SUBJECT: GATEWAY AVIATION D-1 VEHICLE MILES TRAVELED (VMT) ANALYSIS

MERIDIAN D-1 GATEWAY AVIATION CENTER TRAFFIC ANALYSIS

To: Wei Sun, City Traffic Engineer
From: Lillyanna Diaz, Consultant Assistant Engineer
CC: Carolina Fernandez, HRG
Date: April 7, 2022
Subject: **MJPA Gateway Aviation D-1 VMT Analysis; Transportation Engineering Division 1st Review Comments**

EXHIBIT 1: PRELIMINARY SITE PLAN

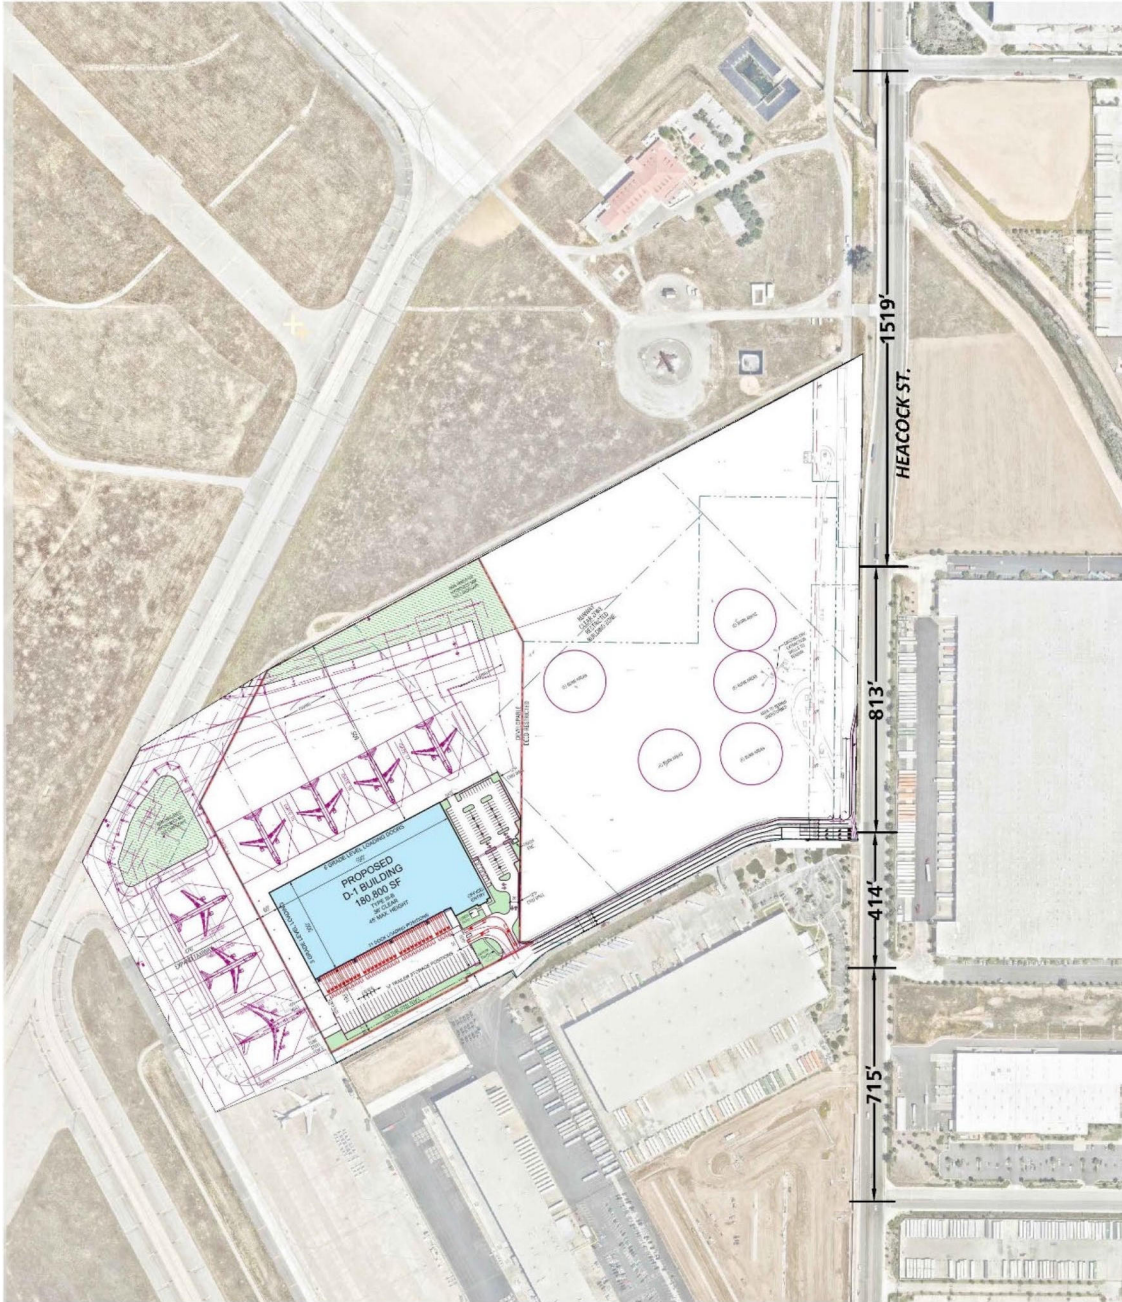
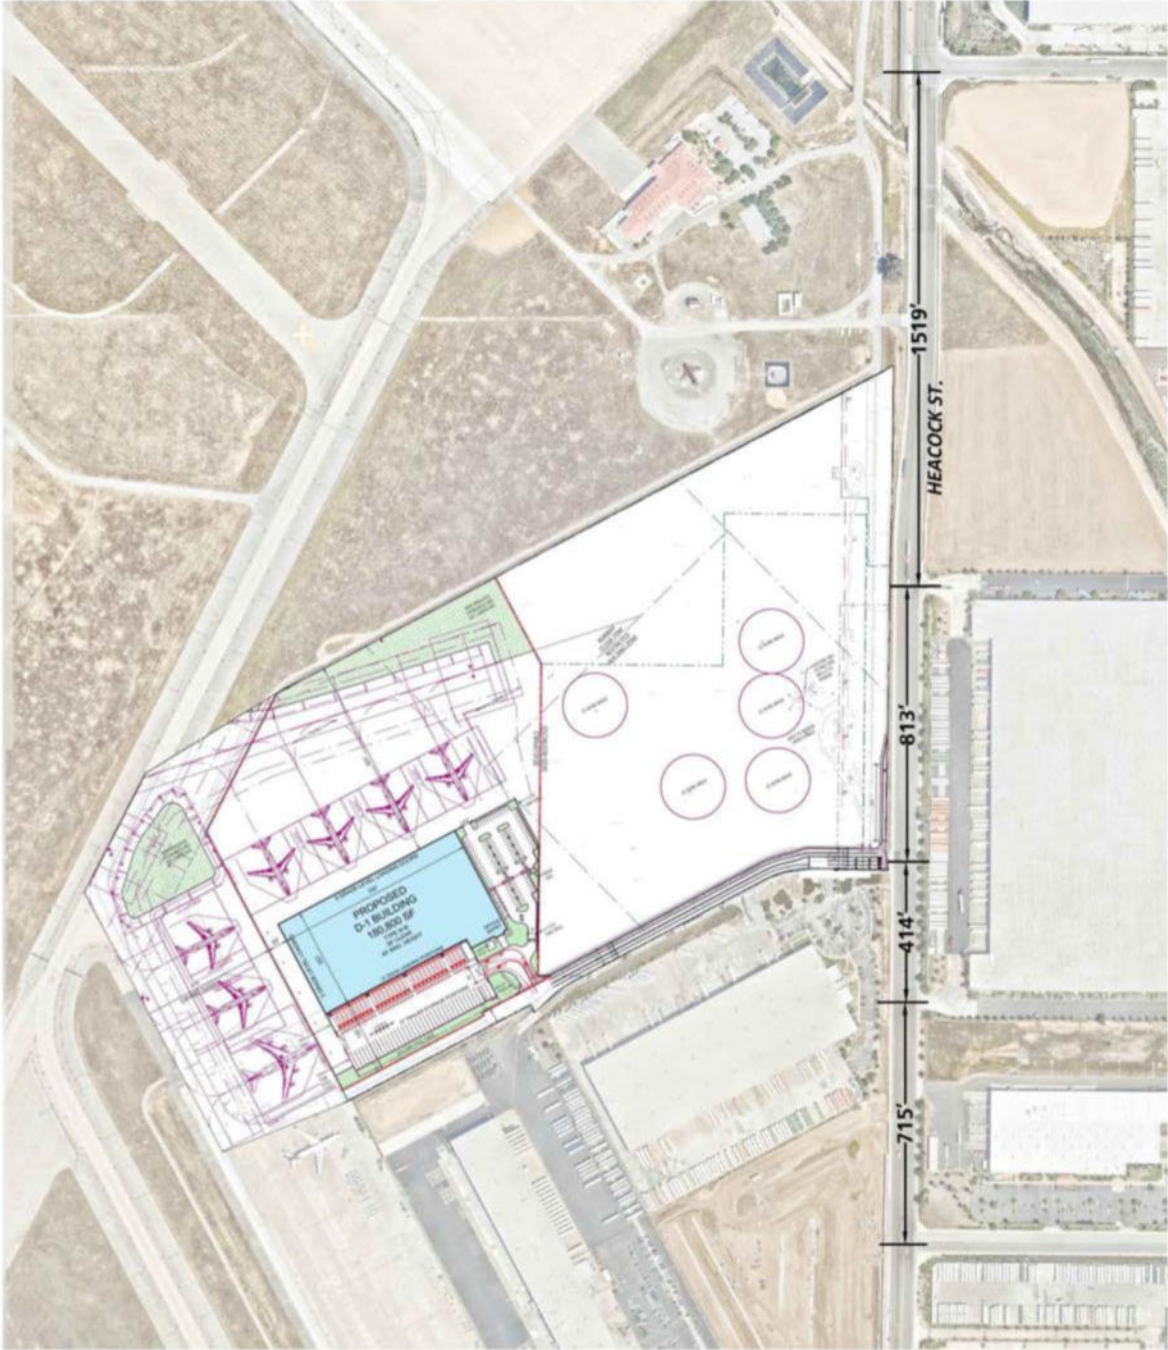
No site plan was provided so the project boundary is unknown, and it is unclear if the project will take direct access onto Heacock. If so, the analysis should identify the VMT impacts within the City of Moreno Valley since the impact will extend beyond the MJPA jurisdiction.

In the original VMT analysis, the preliminary site plan has been added as Exhibit 1. The proposed Project will take access on Heacock Street via Driveway 1, as shown on Exhibit 1.
